City of Oakley
ADDENDUM NO. 1 to contract documents for
OAKLEY RECREATION CENTER PROJECT
CIP # 194

BID OPENING DATE: March 8, 2018 at 2:00pm

Notice is hereby given that the following clarifications and revisions are made to the above referenced contract documents:

Drawing Number:
E3.3

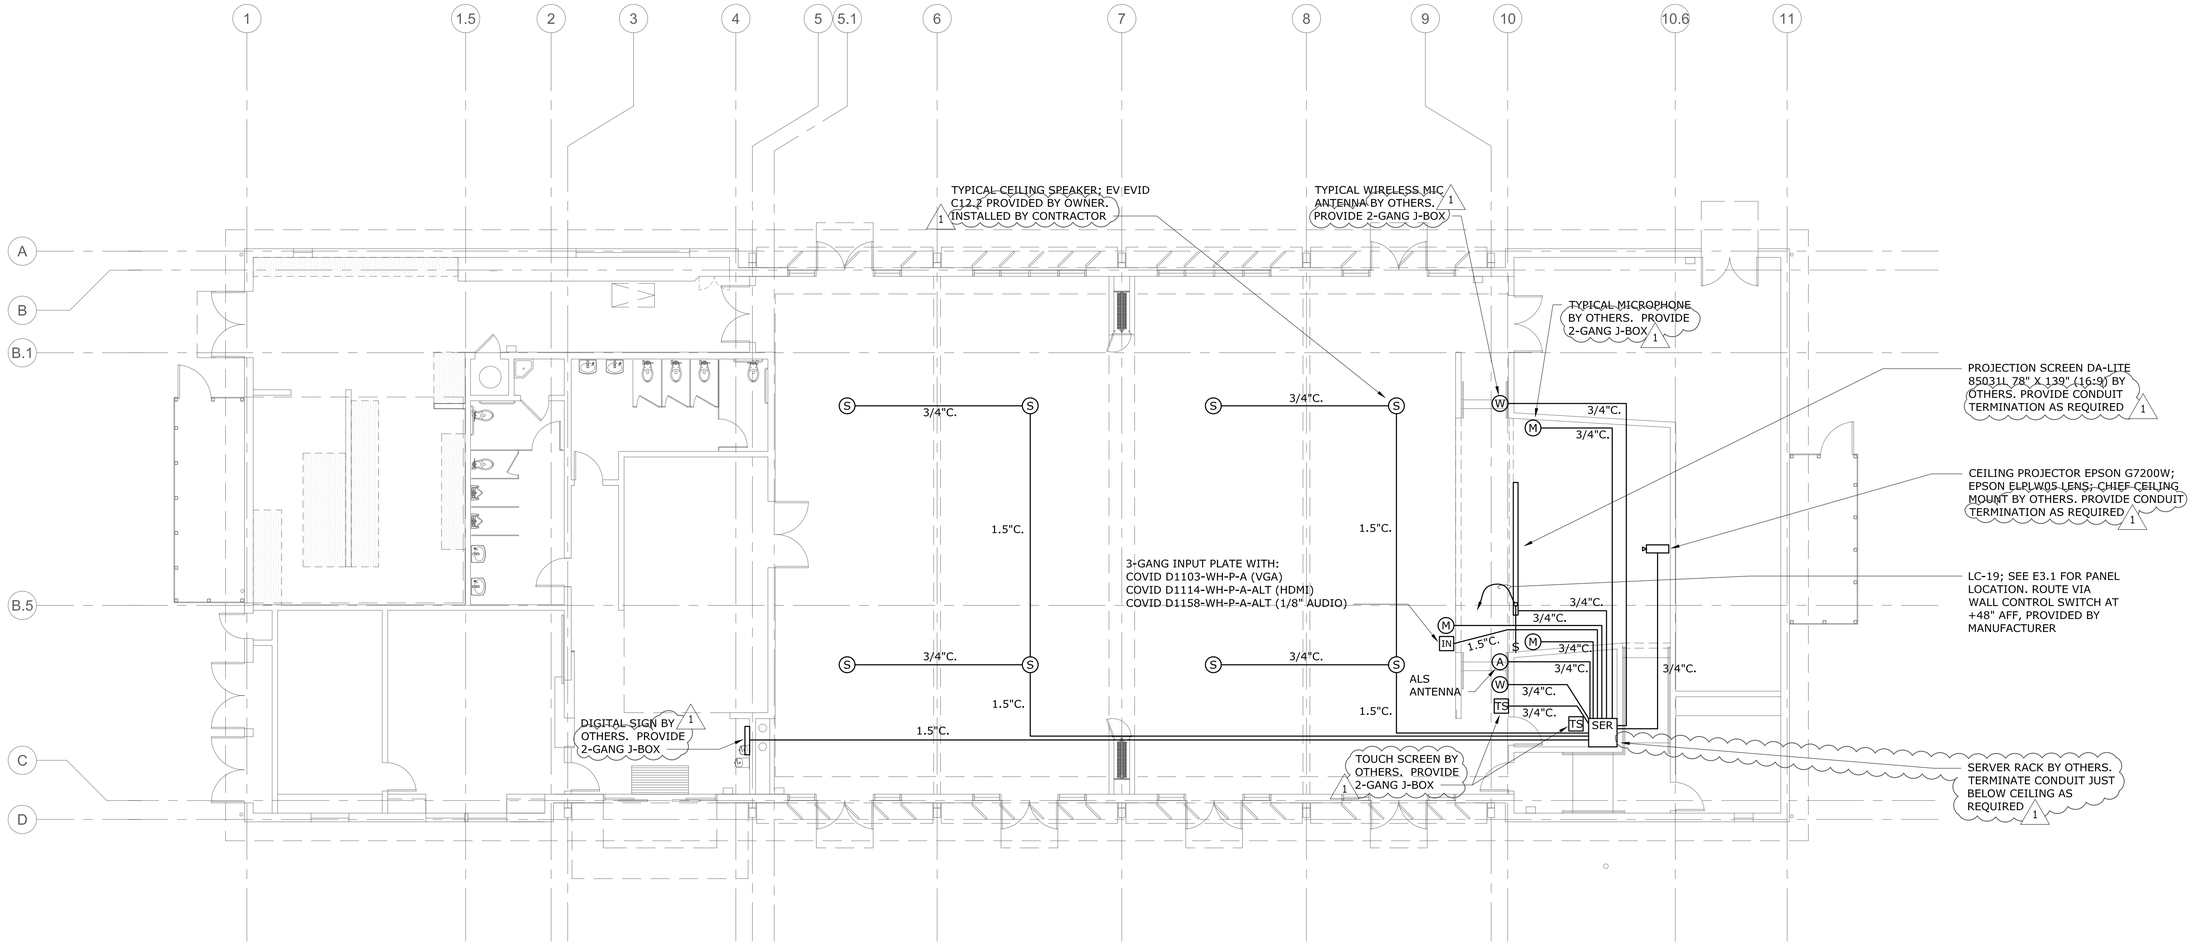
E3.3 1. A/V system clarification to note which devices are by others and which devices are by the Contractor. See attached full sheet E3.3.
